INNOVA APARTMENTS (FKA NOVAPLEX) JSP19-24

Public hearing at the request of BC Novaplex, LLC for Planning Commission's consideration of Preliminary Site Plan, Phasing Plan, Wetland Permit, Woodland Permit, and Storm Water Management Plan. The subject property zoned RM-2 with a Planned Rezoning Overlay (PRO), which conditions development to the terms of a PRO Plan and Agreement. The site is approximately 22 acres and is located on the west side of Haggerty Road, north of Twelve Mile Road (Section 12). The applicant is proposing to develop a 272-unit multiple-family residential development. The development consists of two attached townhome-style buildings and seven apartment-style buildings as well as a clubhouse. The development is a private street network with two entrances off of Haggerty Road.

PLAN REVIEW CENTER REPORT
Planning Review
 November 6, 2020
JSP19-24 Innova Apartments (fka Novaplex)

WETLAND & BUFFER IMPACT PLAN
INNOVA APARTMENTS
 PART OF THE SE 1/4 OF SECTION 12, T. 1 N., R. 4 E.,
 CITY OF NOVI, OAKLAND COUNTY, MICHIGAN

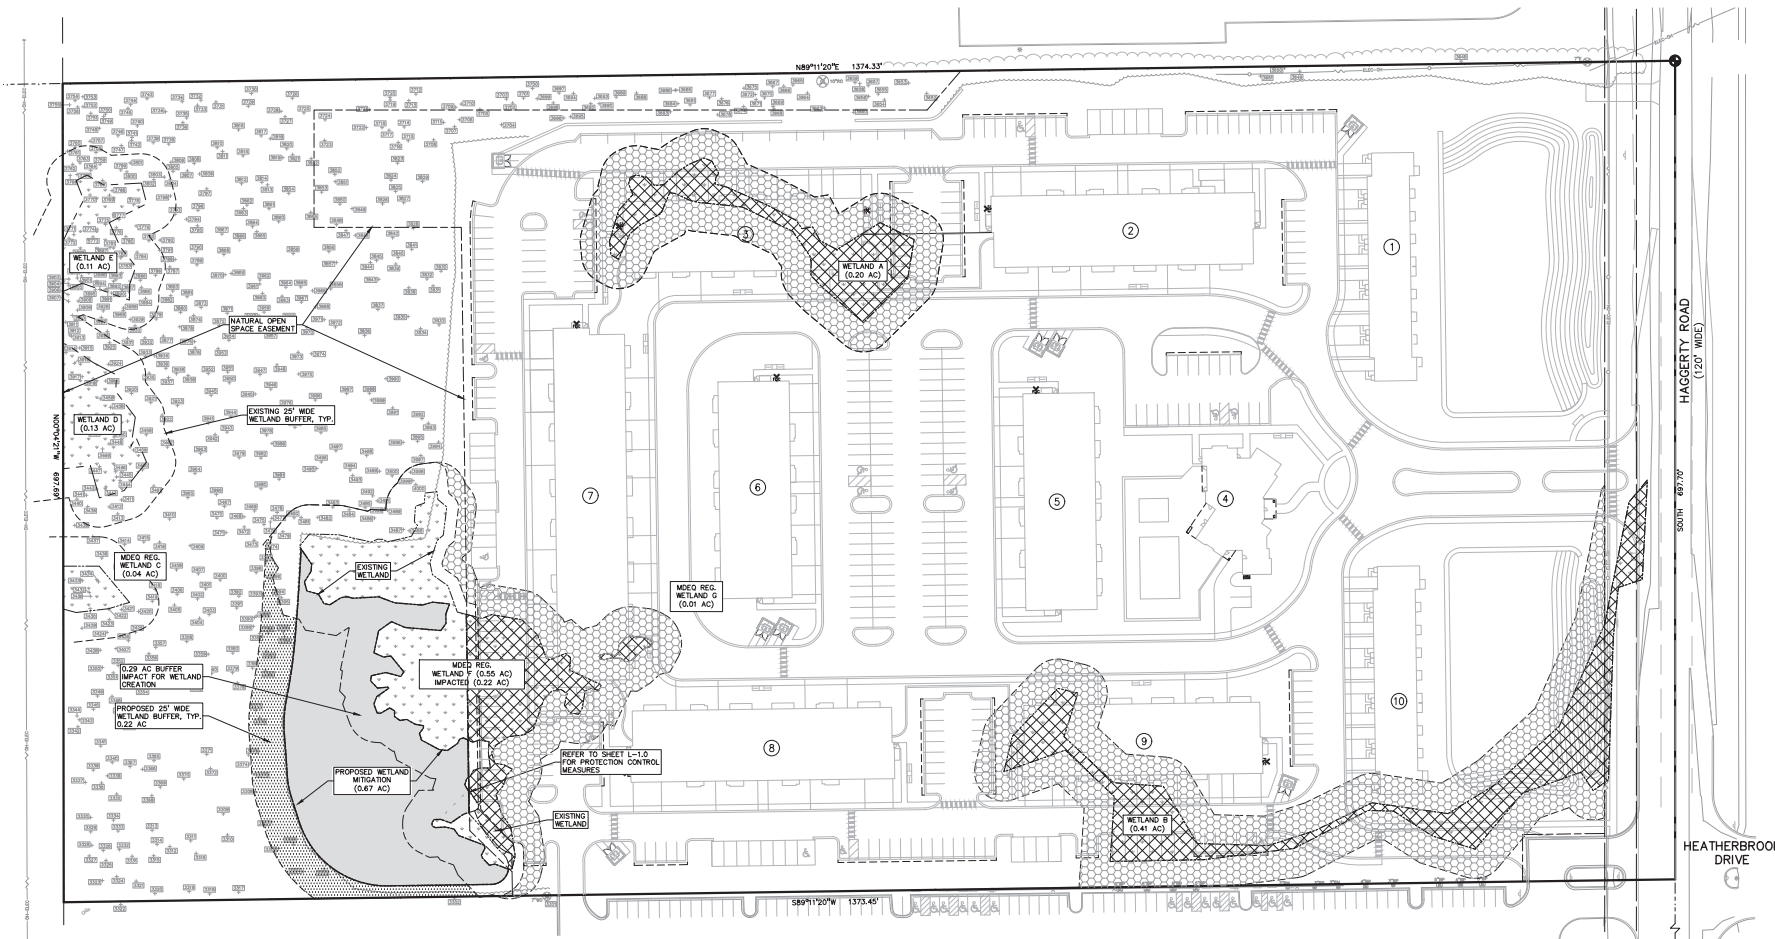
The Plan indicates seven (7) areas of existing wetland on the development site (Sheet C-2.3; *Wetland Impact Plan*). The Plan currently proposes impacts to four (4) of these wetlands (i.e., Wetlands A, B, F, and G). Wetlands C, D, and E are proposed to be preserved.

HEATHERBROOK DRIVE
 ORIGINAL ISSUE DATE: SEPTEMBER 2, 2020
 PEA JOB NO. 2015-298
 SCALE: 1" = 50'
 DRAWING NUMBER: L-1.0

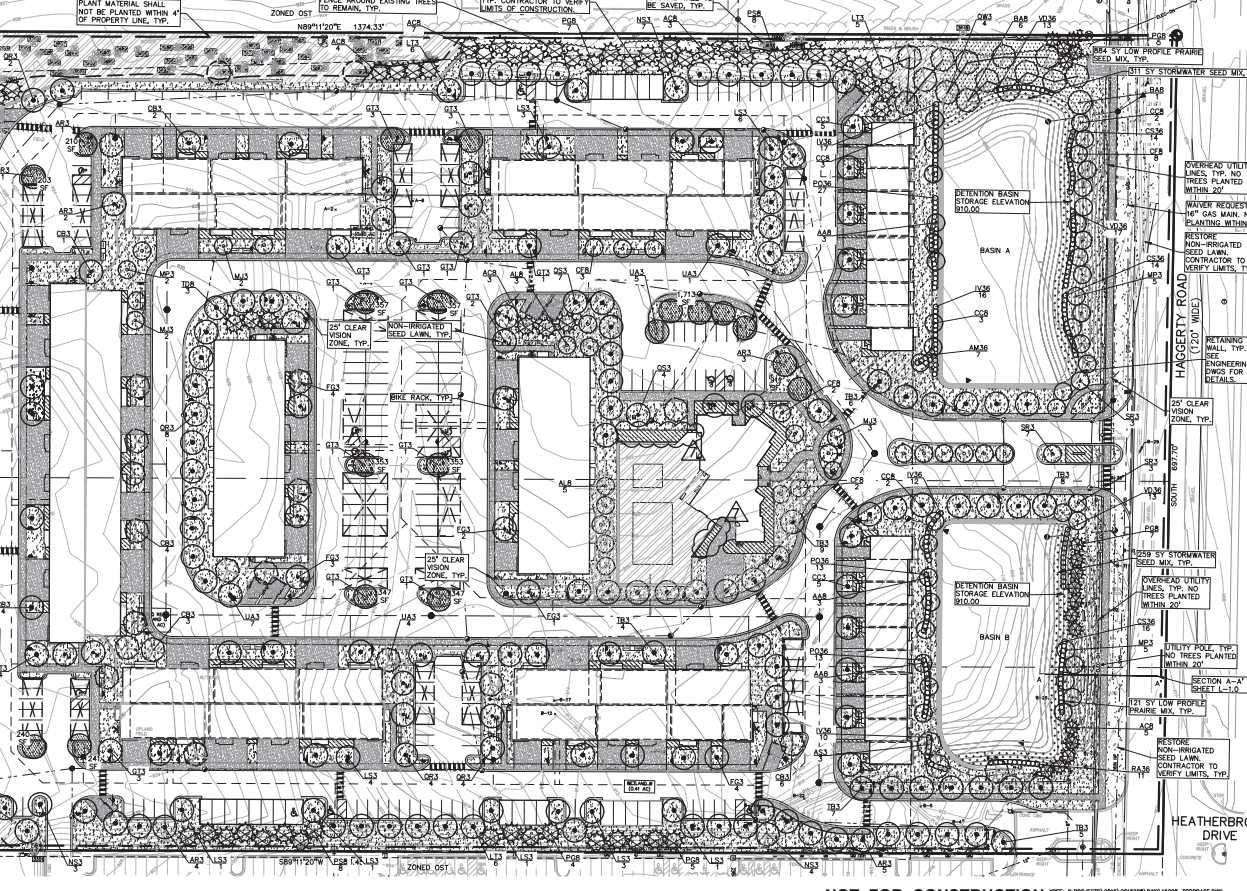
- Calculation was revised and the additional square footage of foundation plantings was added. Please sheet L-1.1 for revised calculation.
8. Please add undulation to the existing berm and provide a cross section of the berm including the overhead utilities.

- Berm now has variation in elevation. Please see sheet L-1.0 for the cross section.
9. Please show sweetgum as a non-native as it is not native to Michigan.

- Sweetgum was changed to a non-native tree. Please see plant list on sheet L-1.0.
10. Please identify all areas on site with *Phragmites australis*.
 - The survey for *Phragmites australis* will be completed prior to the final site plan submittal.

PRELIM. TREE PRESERVATION PLAN
INNOVA APARTMENTS

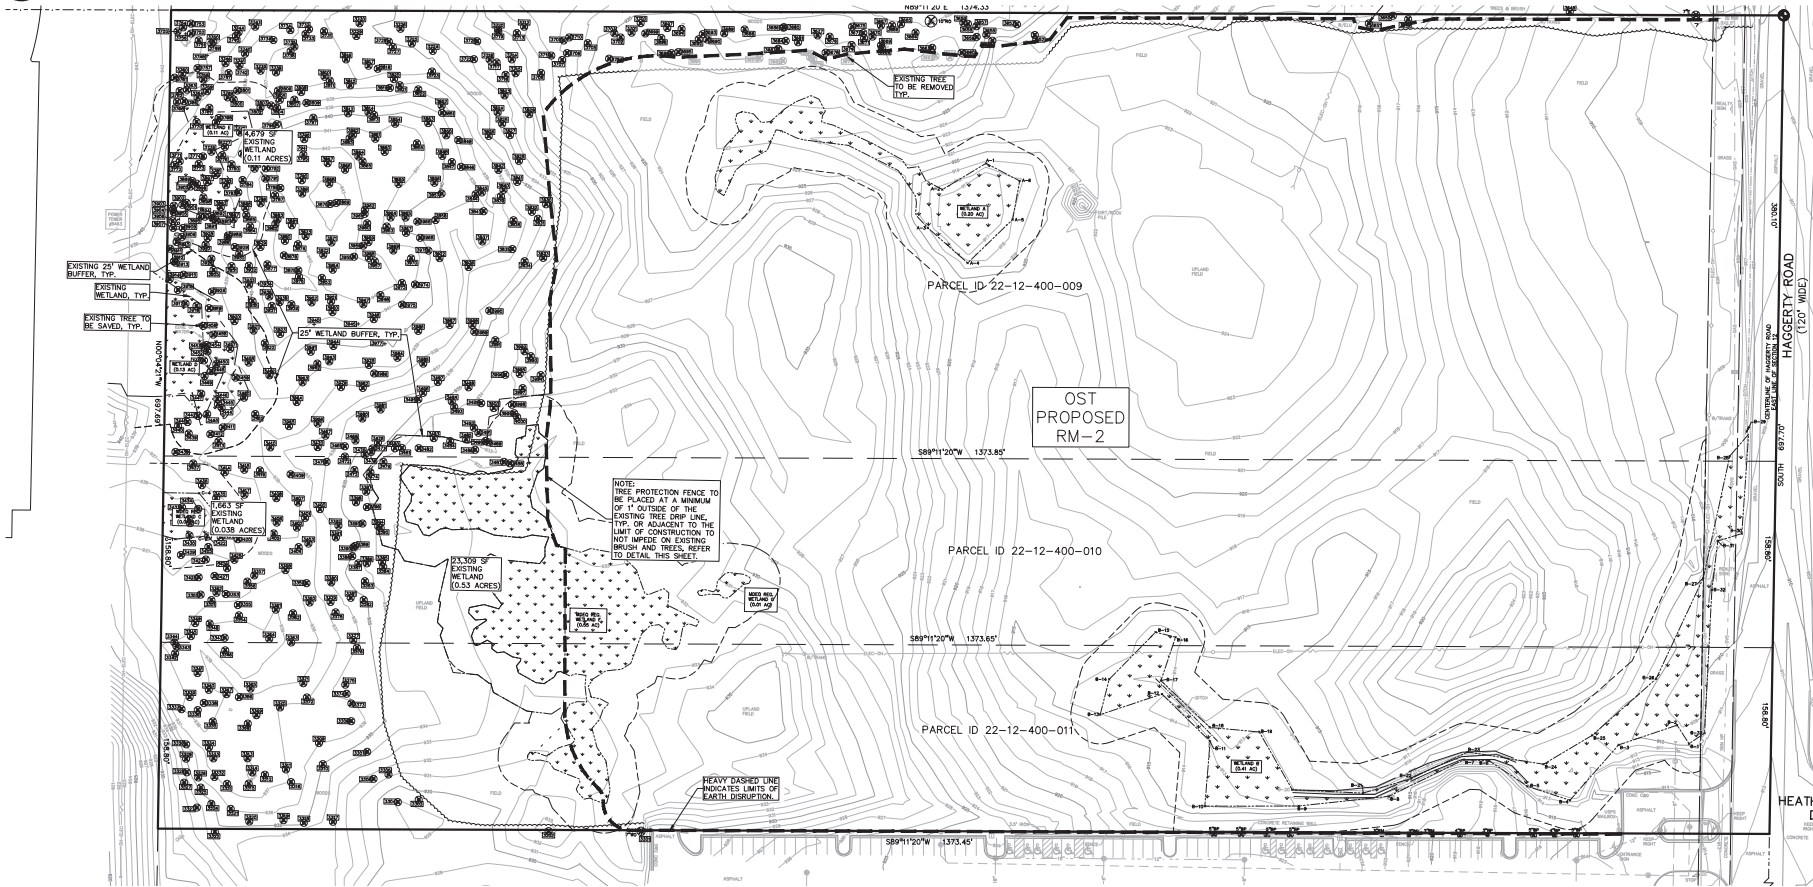
1. All trees to be removed are clearly indicated on Sheets T-1.0 – T-1.2.
2. **Please correct the note regarding replacement trees provided on Sheet T-1.0.**
3. **Please do not propose any new tree plantings within the protected woodlands.**

1. Please copy the location map to the landscape plans
 - Location map added to sheet L-1.0.
2. Please revise the note on T-1.0 regarding replacement trees. Add note stating deposit will be made to the tree fund for the amount due.
 - The note was updated on T-1.0. The calculation for the tree fund was added to the existing note regarding paying into the tree fund on T-1.0 and L-1.1.

CARPORT DETAIL

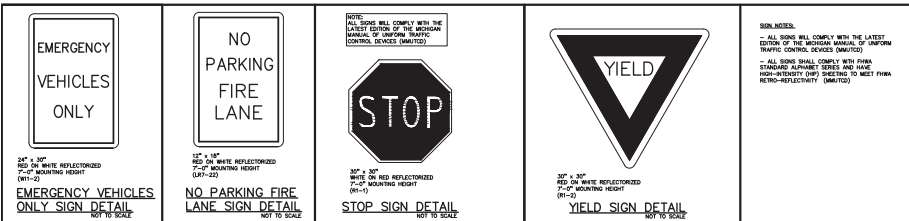
7. Carport Design: The applicant has not addressed the façade comment in their response letter that the carports do not include the required brick on the end elevations, and revisions to the carport design have not been included in this submittal. **As stated in the PRO Agreement "The carport design shall provide for side paneling that shall include a brick surface, consistent with the examples provided as exhibits to the Planning Commission and City Council."**
